**CONWAY**  
HISTORIC DISTRICT COMMISSION  
STAFF REPORT

**5:30pm • April 23, 2018 • City Hall**

# C1 NEW SINGLE FAMILY RESIDENCE - 1822 JOHNSTON AVENUE

## C2 NEW PORCH ADDITION - 1935 SIMMS STREET

Site Plan

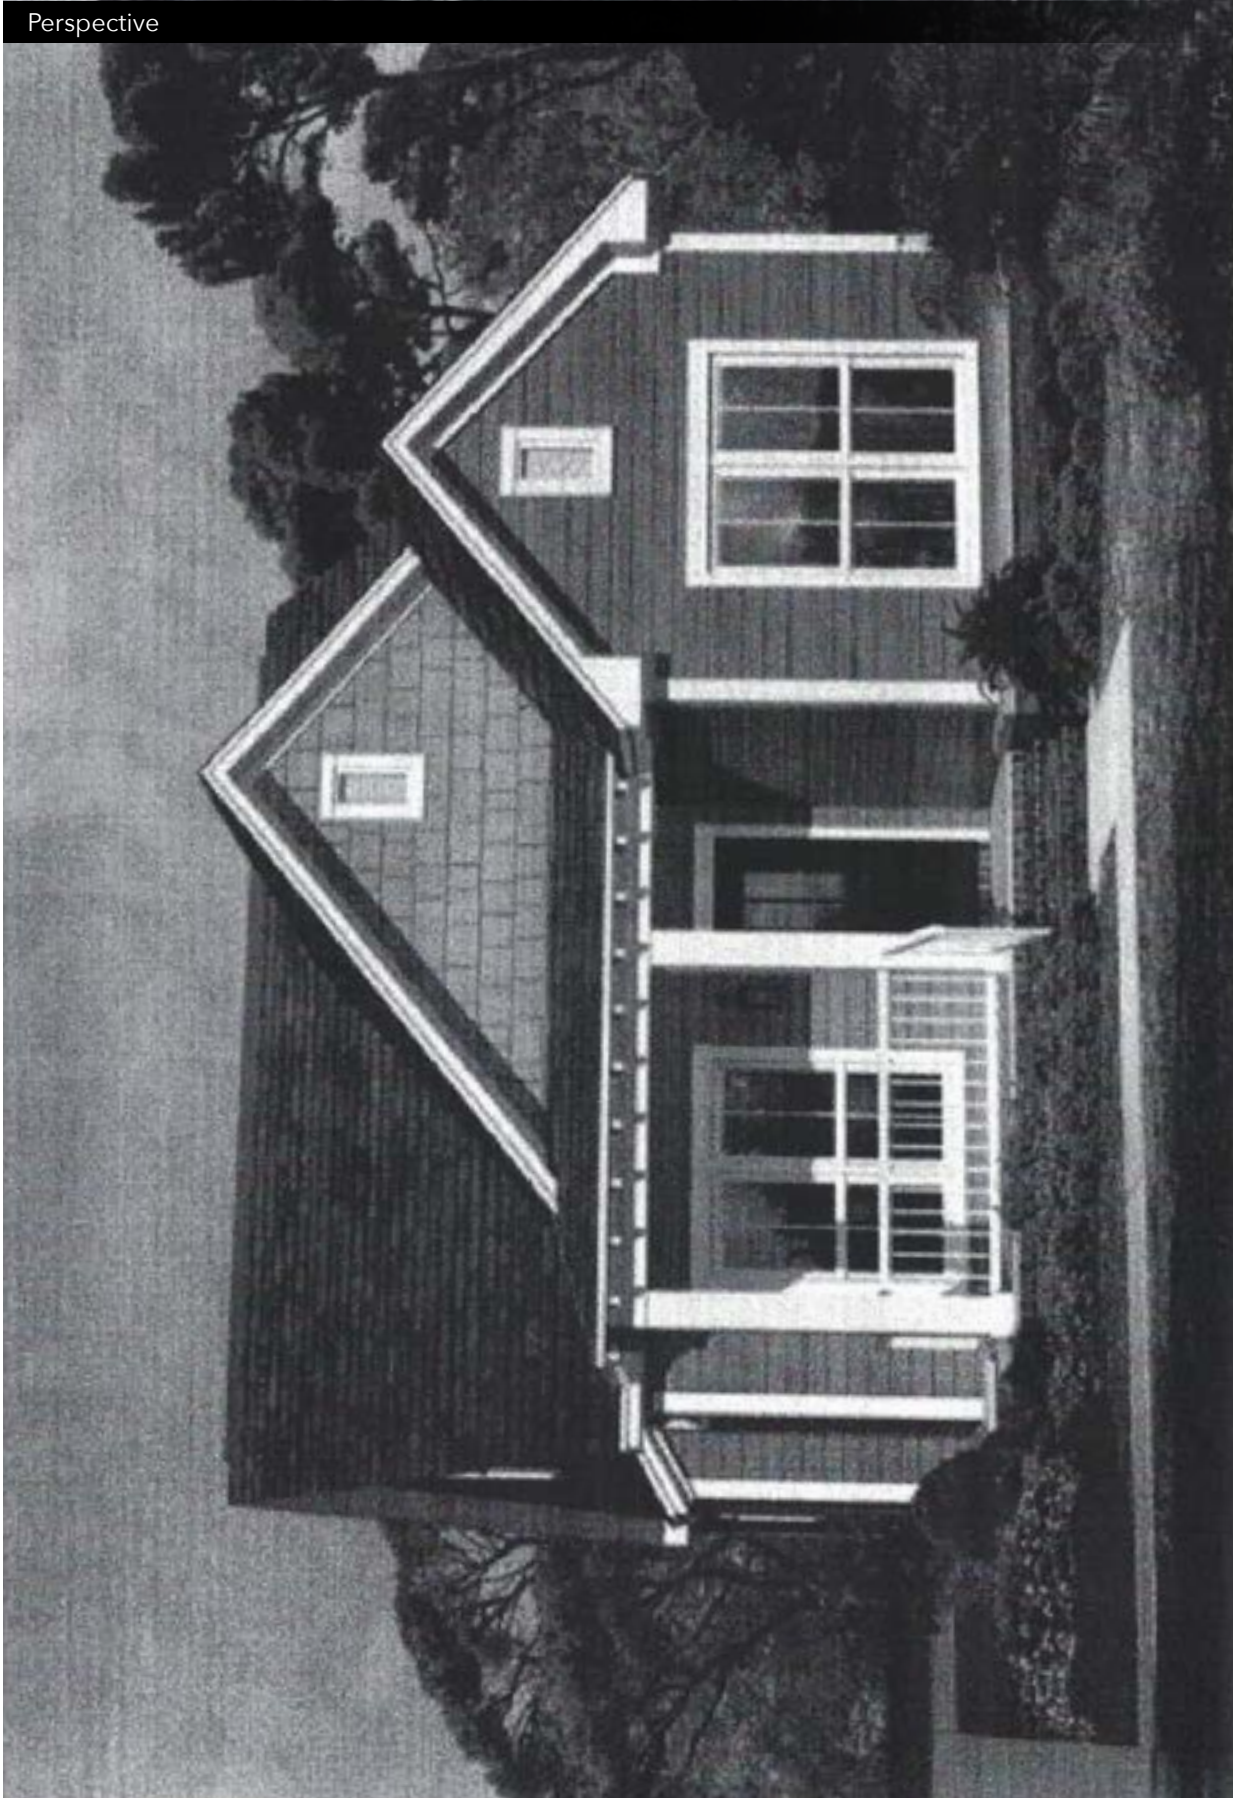
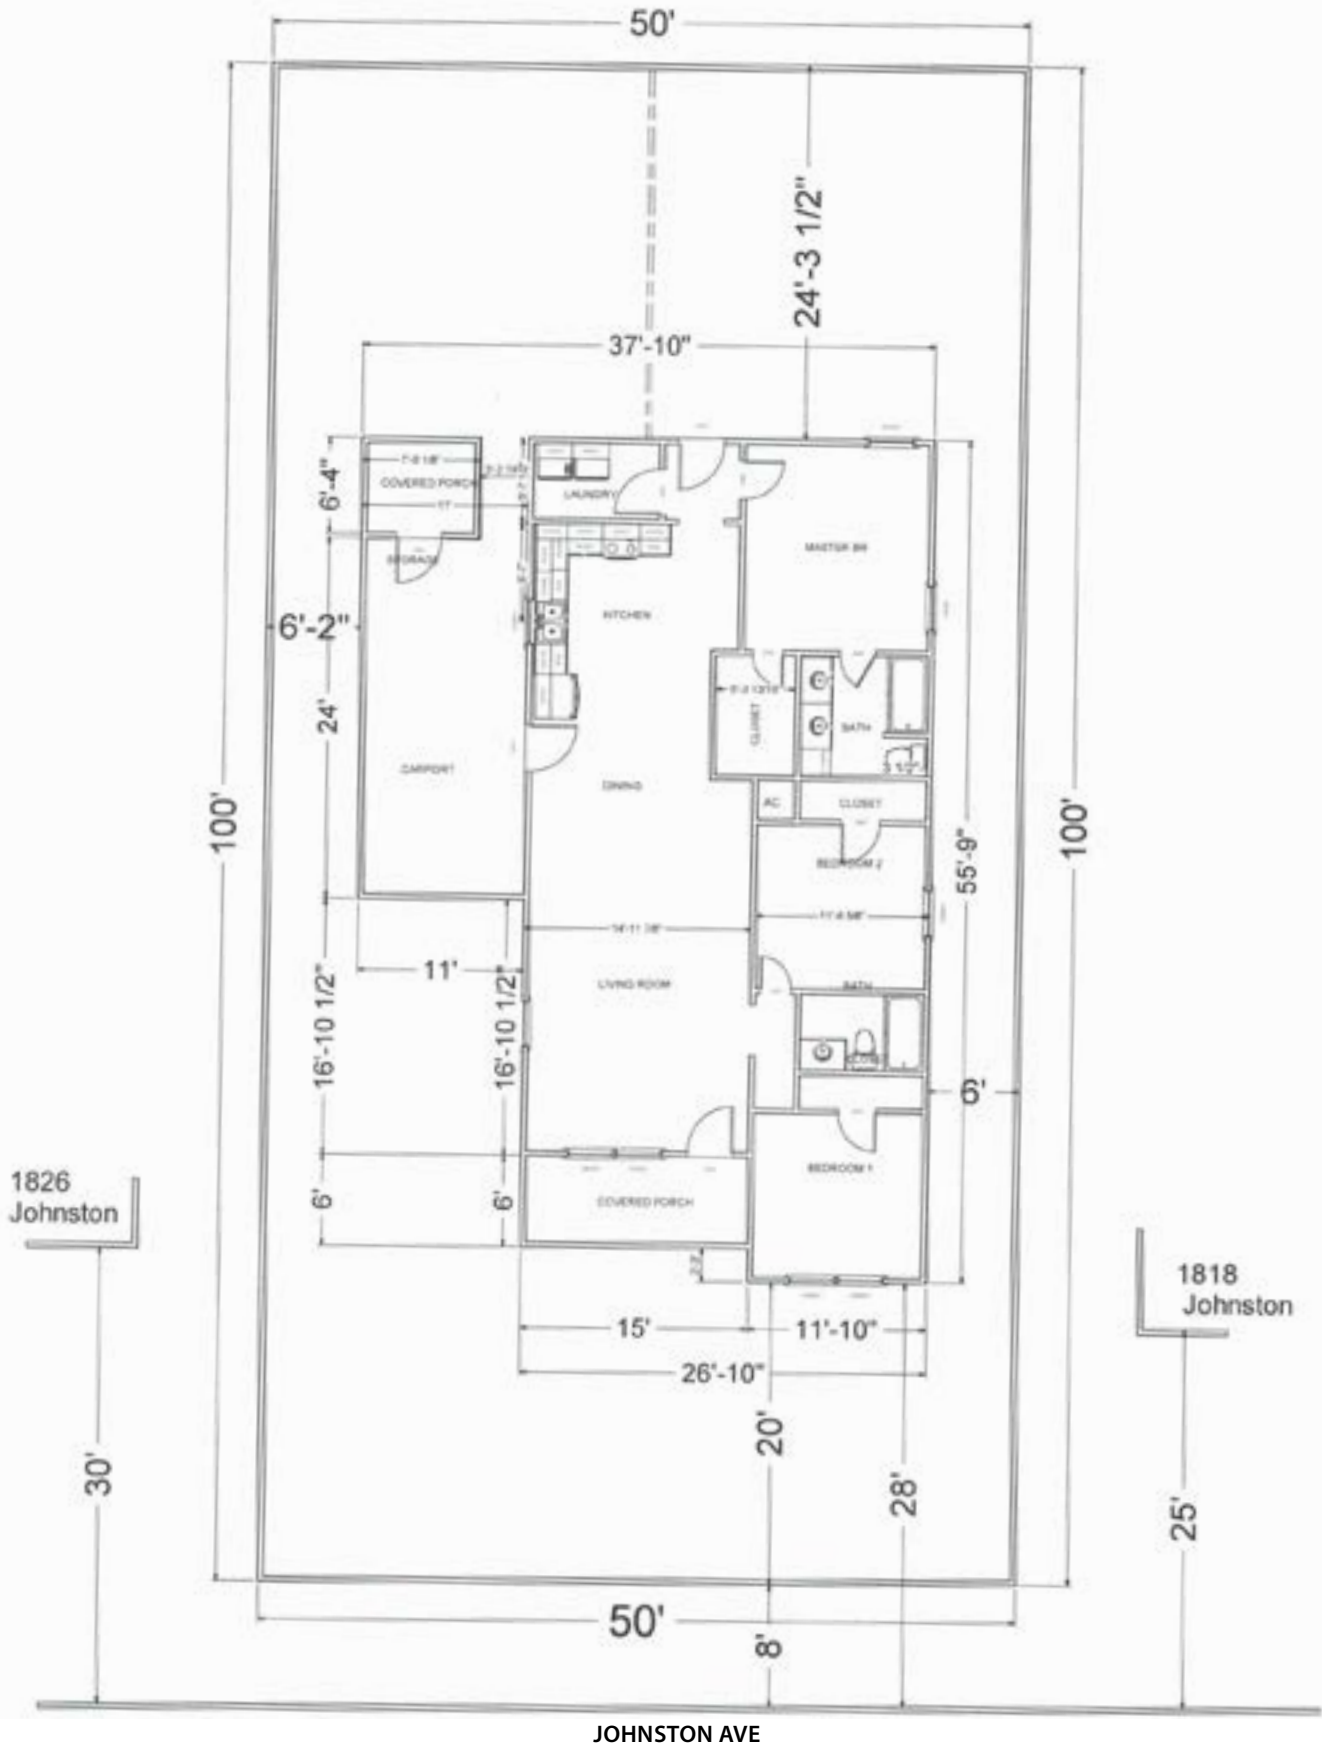
**Setbacks.** Proposed setbacks should respect the predominant setbacks of area structures, especially the front setback. Front setbacks are allowed within a range of 85% to 115% of the average area front setback. The average area setback from the curb is 25'-6". The proposed front setback is 28 feet from the curb. The maximum allowed front setback is 29 feet while the minimum is 21 feet. The proposed front setback of 28 feet from the curb is appropriate. This curb to house setback translates to approximately 13'-6" from the property line. The side setbacks are at least 6 feet and the rear is 24+ feet. These setbacks are appropriate.

**Driveway/Parking/Carport.** There is an existing gravel driveway onto the vacant property. The proposed residence will be served by a driveway on the west side of the property. The driveway width is not specified. However, the residence has a 1 car carport. The driveway should be limited to 12 feet in width.

**Complexity of form.** The level of detailing and breaks in wall planes of a structure. The residence has appropriate detailing accomplished with wide window and door trim. The residence's wall planes are broken by a gabled front facade and a small porch. Gables are also used on the sides. The floor plan shows a carport with rear storage areas. The perspective view does not show the carport. A staff created sketch shows the roof line and carport side elevation.

**Entries, Porches, and Porticos.** Appropriate entry points are provided. Porches are to be a minimum of 6 feet in depth. The front porch shown is small, but minimally 6 feet in depth. Porch column width has a solid appearance. The column width should also be used on carport columns.

**Doors and windows.** The doors and windows shown have muntin dividers creating two over two windows. Simple one over one windows would be more appropriate than windows with false dividers.

**Architectural Details, Siding, and Bricks.** Eaves, brackets, dentils, cornices, molding, columns, trim, etc. The residence has detailing provided through wide door and window trim and open rafter tails over the front porch. These features add traditional detailing. The applicant has stated that fiber cement siding is to be used on the front facade with vinyl siding on the other elevations. Fiber cement siding is preferred.

1. The residence shall be constructed as shown in submitted plans.
2. Driveway shall be concrete maximum of 12 feet in width.
3. The residence's front setback shall be approximately 28 feet from the curb or approximately 13'-6" from the property line or best dimension to line up with existing residences.

4. Porch columns including carport columns shall be a trimmed out to approximately 8 inches by 8 inches.
5. Floor to ceiling height shall be 9 foot minimum.

6. Siding material shall be vinyl with Hardi-plank or equivalent fiber cement board on front facade areas.
7. Wide trim around windows and doors, open rafter tails, and mixture of siding shall be used as shown.

8. One over one windows are preferred rather than windows with false dividers
9. HVAC and utility equipment shall be appropriately located at the rear or side of the structure and/or appropriately screened.

10. The existing sidewalk shall be repaired and/or re-constructed along Johnston Avenue.

Applicant provided sketches

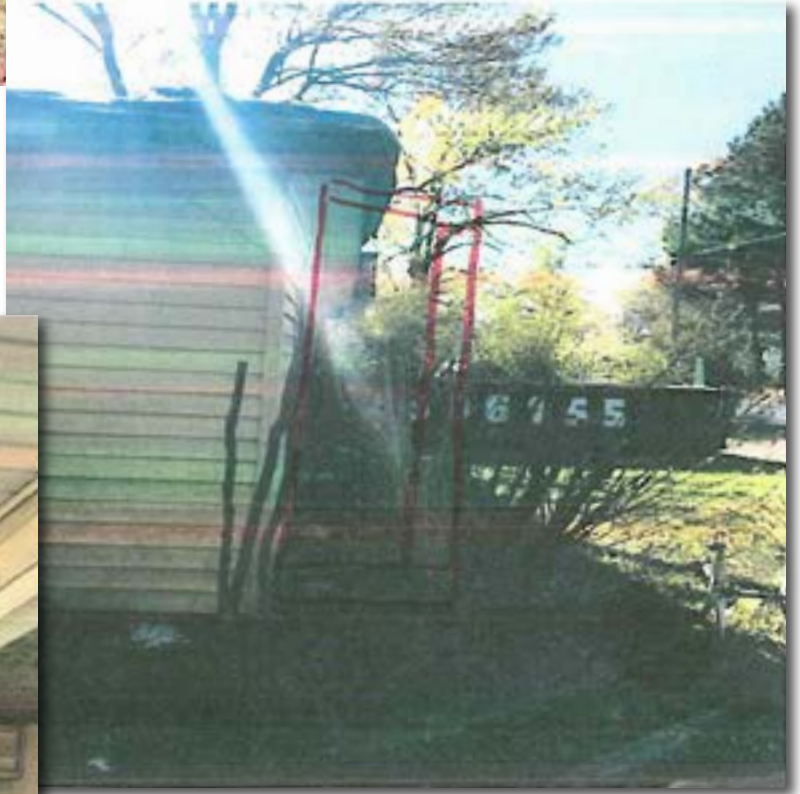
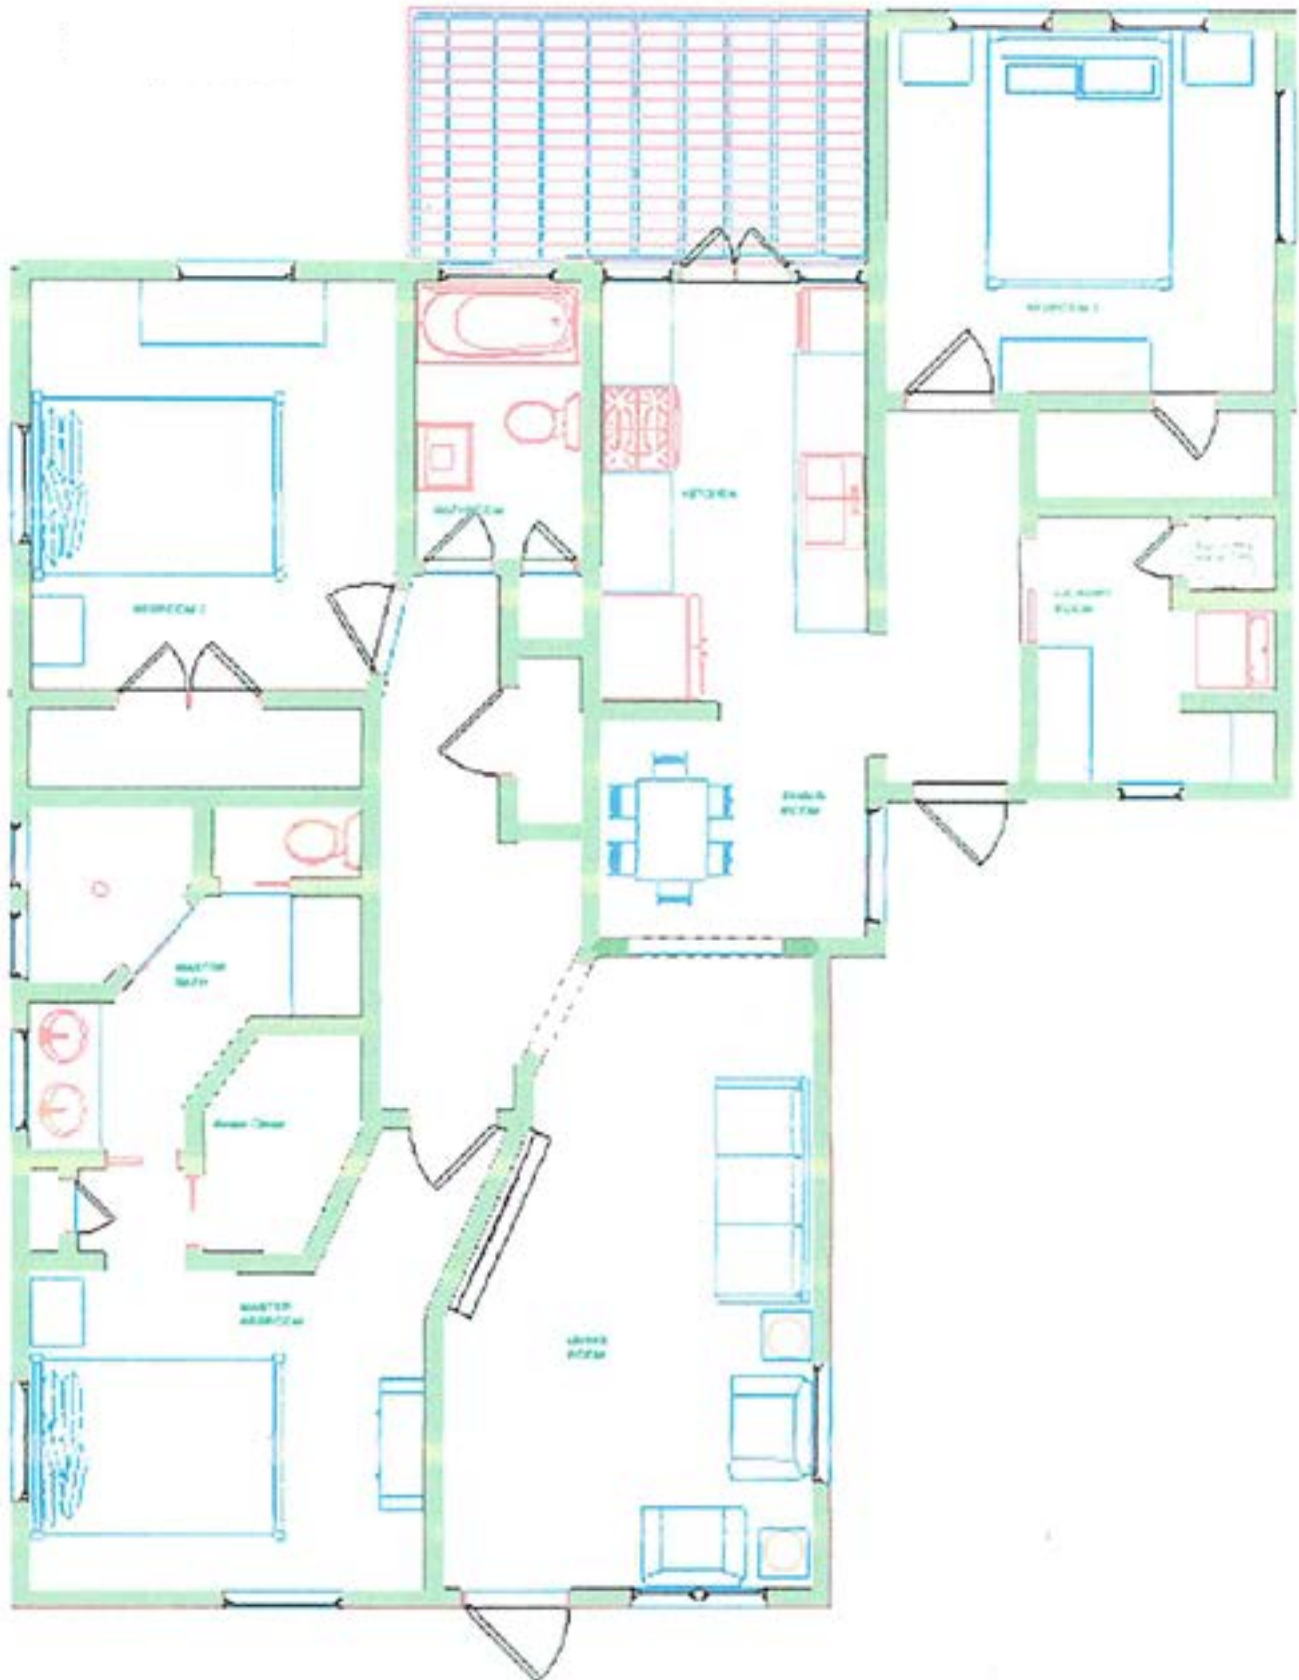
**Entries, Porches, and Porticos.** Appropriate entry points are provided. Porches are to be a minimum of 6 feet in depth. The front porch should minimally be 6 feet in depth. Porch column widths should have a solid appearance. New wider columns could also be used to replace the existing carport columns.

**Doors and windows.** The doors and windows appear to be replacement windows. The applicant would like to replace the existing windows with vinyl windows similar to 320 Mitchell as shown in submitted materials. The proposed windows have false dividers on the upper sash. A simple one over one window scheme could be used as opposed to false dividers.

**Architectural Details, Siding, and Bricks.** Eaves, brackets, dentils, cornices, molding, columns, trim, etc. The existing residence has little detailing. The proposed porch will provide a new level of detailing through an emphasized gable, wide porch columns, and gable louver. The residence is currently covered with a single color vinyl siding. The applicant is proposing new replacement vinyl siding with contracting colors.

1. The front porch addition shall be constructed as shown in submitted plans. Porch shall be 6 feet minimum in depth.
2. The residence's front setback shall be approximately 29 feet from the curb.
3. Porch columns including carport columns shall be a trimmed out to approximately 8 inches by 8 inches.
4. Doors and windows may be replaced as submitted.
5. Fencing?
6. The existing vinyl siding may be replaced with new vinyl siding.
7. Wide trim around windows and doors shall be used as shown.
8. One over one windows are preferred rather than windows with false dividers.
9. Architectural asphalt roof shall be used.
10. No sidewalk construction is required.
